2005 Edition of ASCE 7
Minimum Design Loads for Buildings and Other Structures
Includes Supplement No. 1

Errata

Errata Posted on May 3, 2007

Chapter 6, Figure 6-19A, page 70:

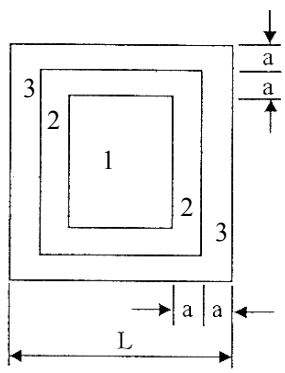
Revise the illustration in the upper left-hand corner to correctly identify the location of the zones. Correct illustration is provided below:

Chapter 10 – Figure 10-1, page 102:

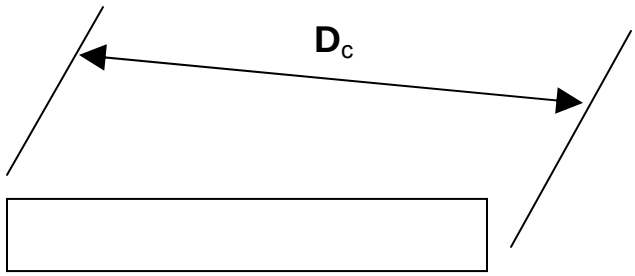
The dimension D_c in the upper right-hand diagram is measured from the upper corner of the rectangle on the left side to the lower corner on the right side as shown below:
